DET26003-A01

1901 Asilomar Drive

RESIDENTIAL APPEALS COMMITTEE STAFF PRESENTATION

APRIL 15TH, 2026

1 DELTA 2 PROPOSED SITE PLAN + LANDSCAPING PLAN
 1/8" = 1'-0"
 (NO CHANGE TO FOOTPRINT OR GRADE)

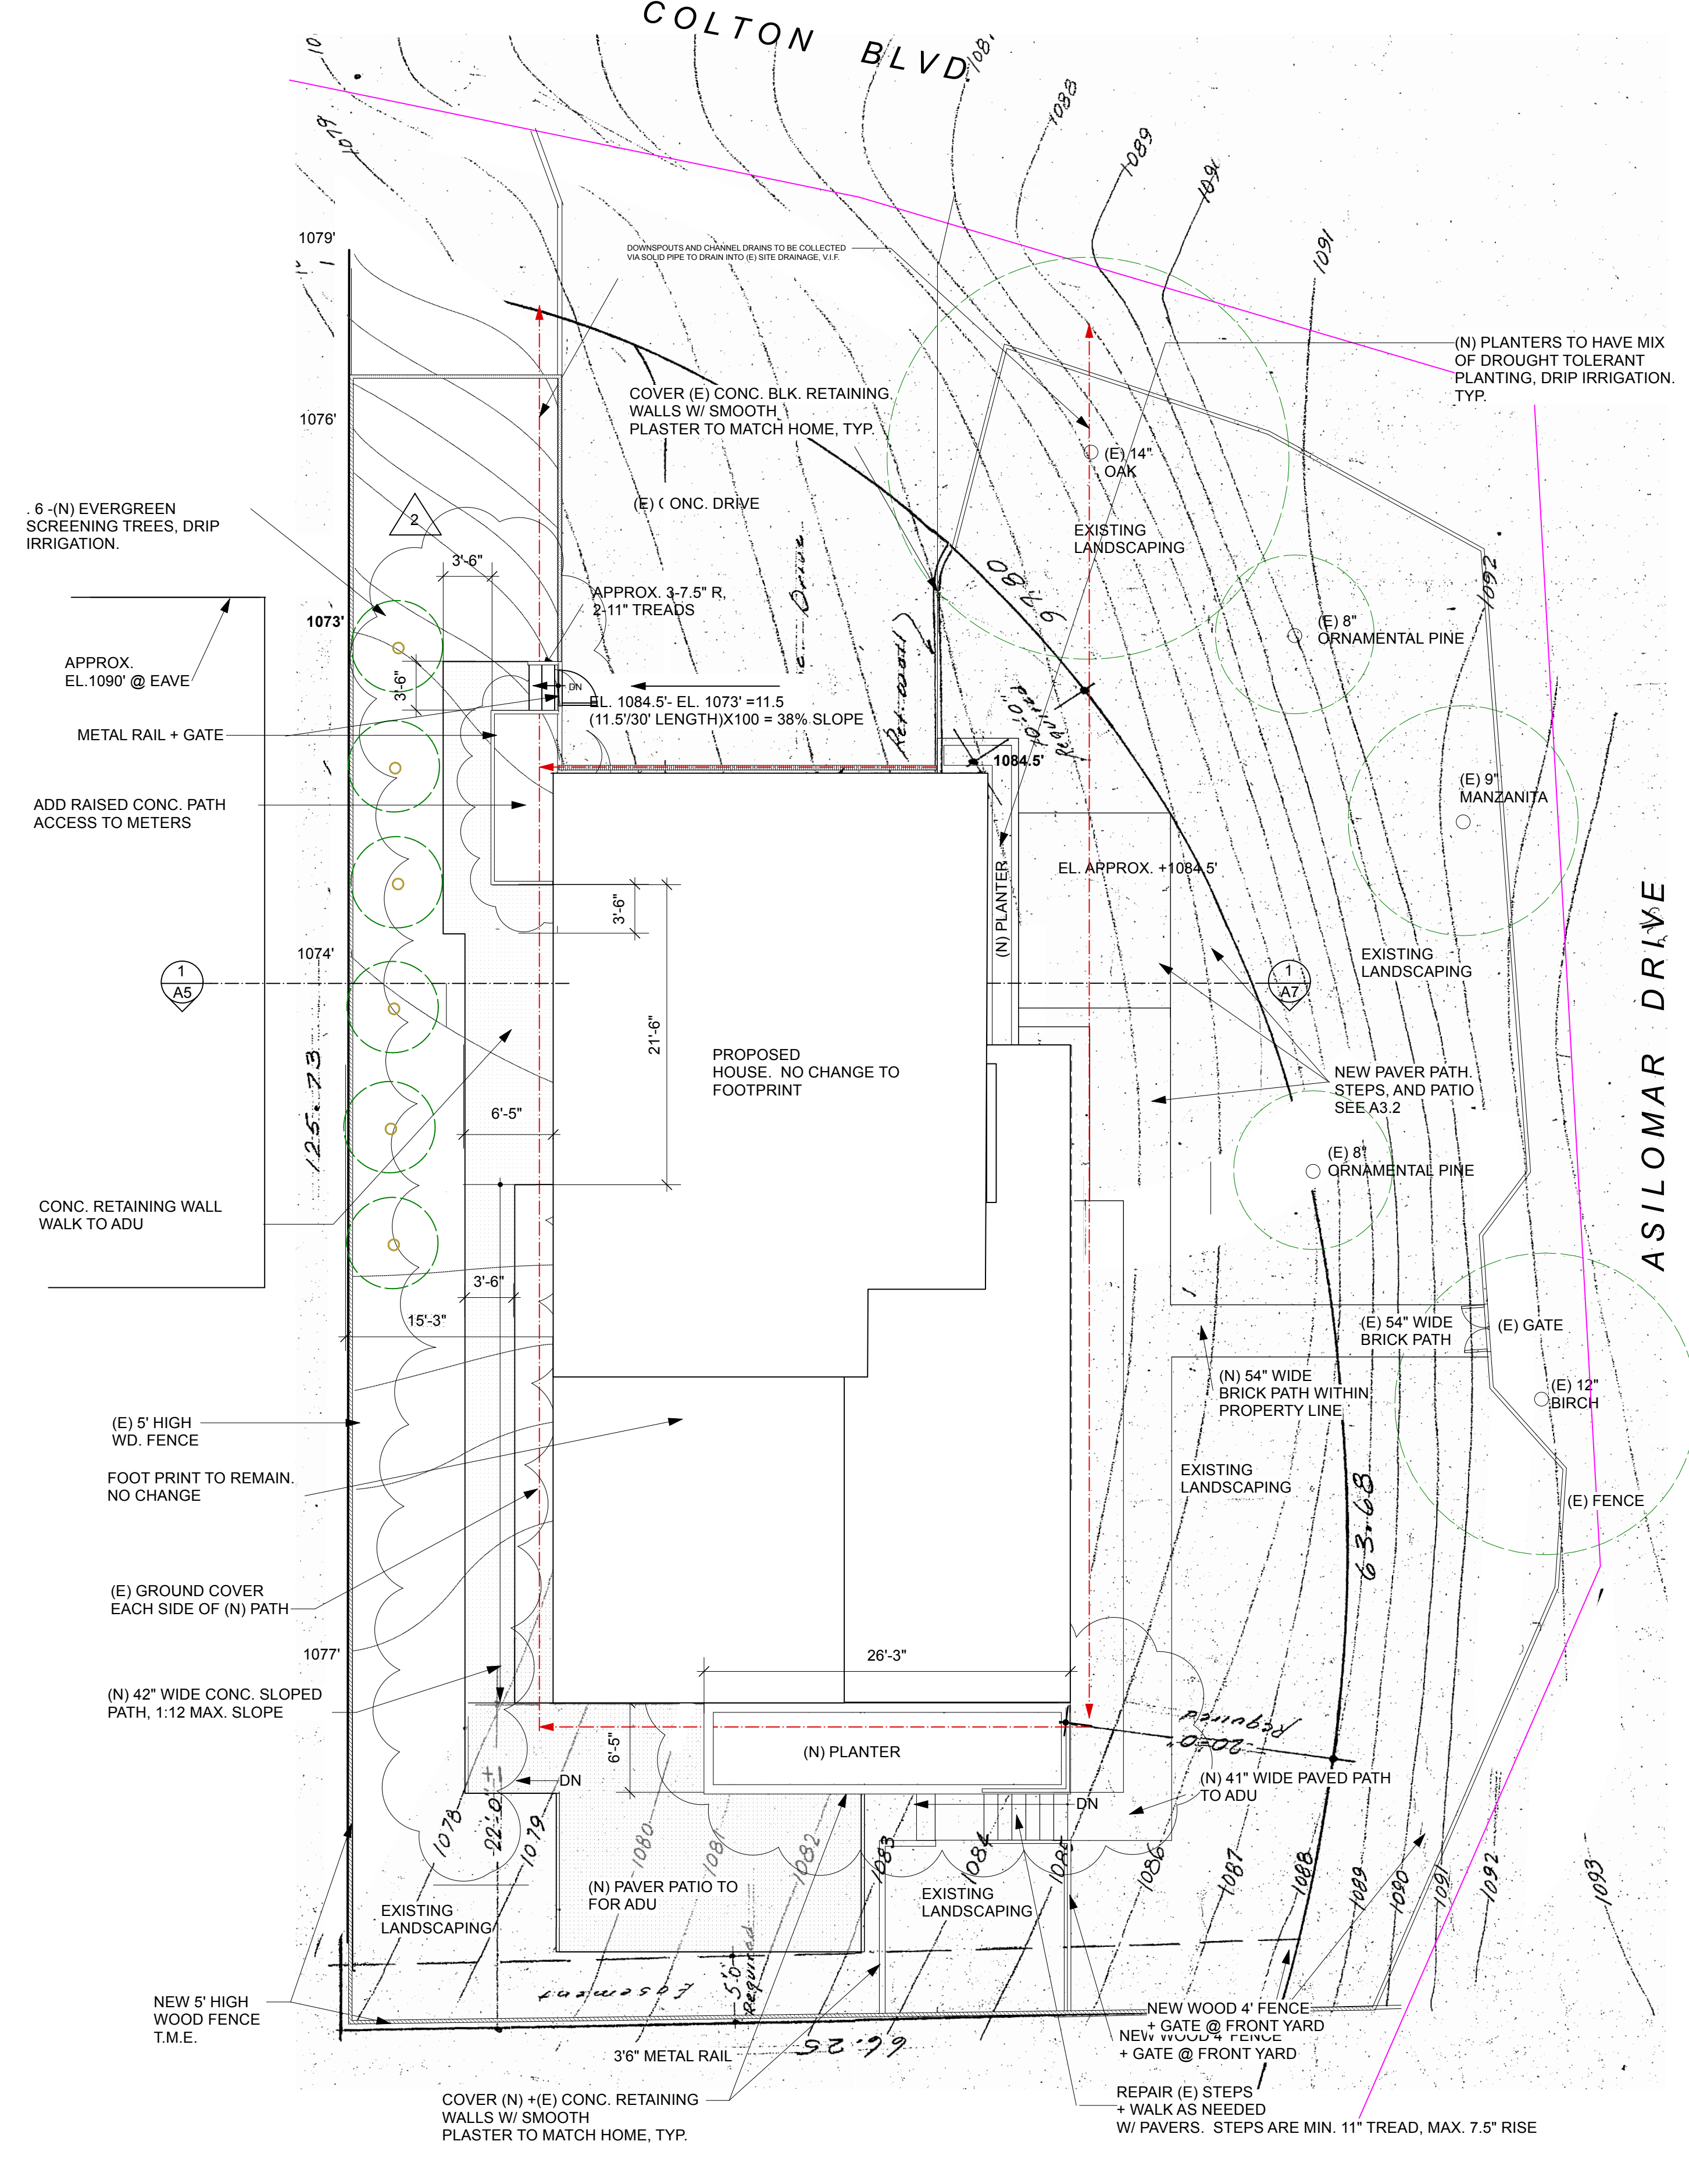
Proposed revisions are grading modifications and the addition of retaining walls ranging in 23 feet high in the side yards.

- Small grading adjustments
- Low retaining walls generally 2–3 feet high
- The short walls are a typical feature of hillside landscaping.
- Retaining walls would not require a Building Permit due to limited height.
- Retaining walls are permitted by-right up to 8 feet tall.
